**DELAWARE ARMY NATIONAL GUARD  
Fire Alarm / Fire Suppression Upgrades  
Dagsboro Readiness Center  
Armory Road  
Dagsboro, Delaware 19939  
State of DE Project #MC 7601000097 ❖ DEARNG # FMO-26697  
DBF #0999J011.L04  
SEPTEMBER 18, 2017**

**ADDENDUM NO. 2**

### WATER SUPPLY GRAPH

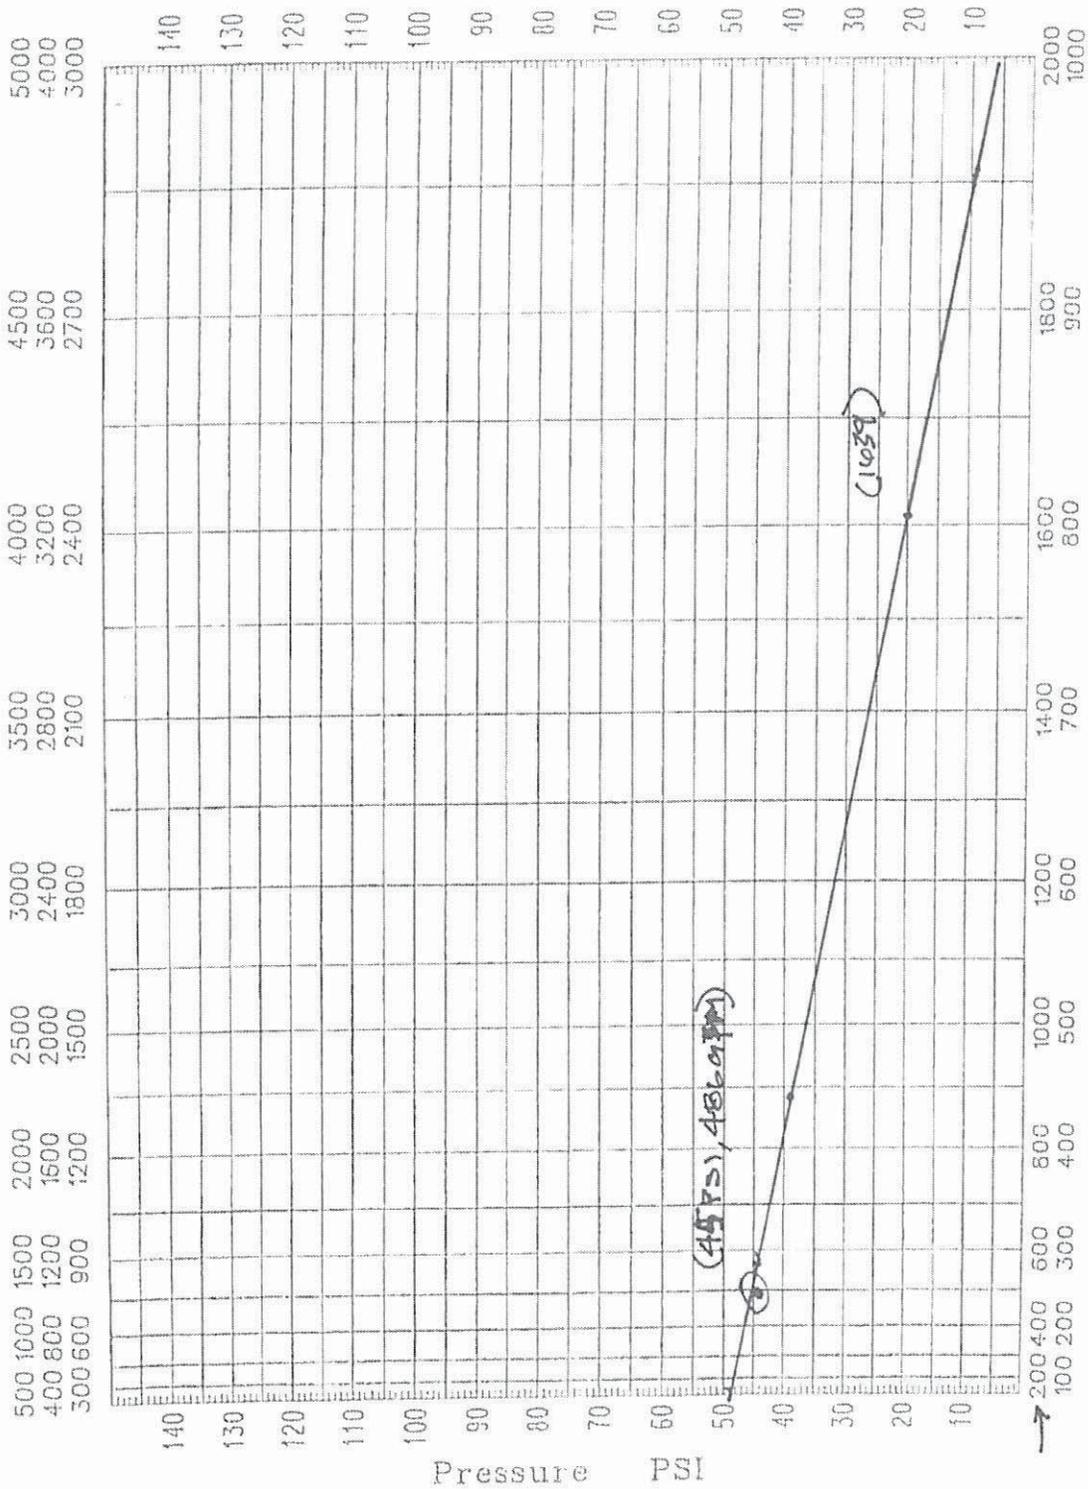
- Item No. 11     A flow test is attached. The winning bidder must have a current flow test performed prior to designing the sprinkler system.
- Item No. 12     Clarification: There are not any standpipes on this project.

Static Pres. 48 PSI  
Residual Pres. 39 PSI  
Flow: 888 GPM
